Control sheet for Standard Engineering Details 0612, 0613, 0614, 0617 and 0626

12 August 2009:

PREPARED BY OPUS:	AUCKLAND <i>CITY</i> Transport	SCALE :	NTS
		DRAWN :	S.M.W
	VEHICLE CROSSING CONSTRUCTION NOTES	ISSUE DATE :	07/2009
		APPROVED : 1:	st July 2009
		PLAN No.	ISSUE C
		2008/06´	17

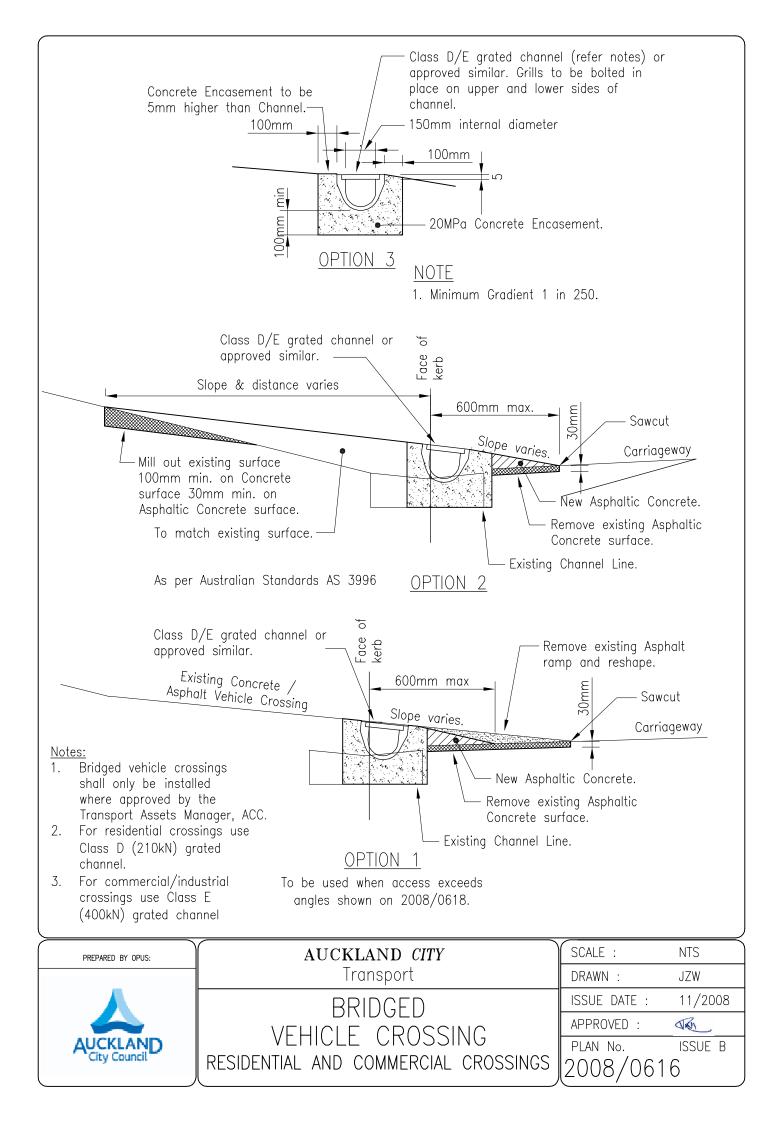
Revisions to standard engineering details as follows:

- Increased height of the 'lip' from 20mm to 50mm.
- Removal of the radial block.
- The taper of the splay at the entrance of the vehicle crossing has been standardised to 600mm on each side.
- For vehicle crossing next to the kerb the ramp depth has been specified to be a minimum of 500mm and a maximum of 800mm to provide for a 1 meter wide continuous footpath plane for pedestrians. Fall to match the full width of the footpath.
- The width of the vehicle crossing at the boundary and at the kerb side has been corrected to reflect a single vehicle entrance i.e 6000 max width dimension has been removed.
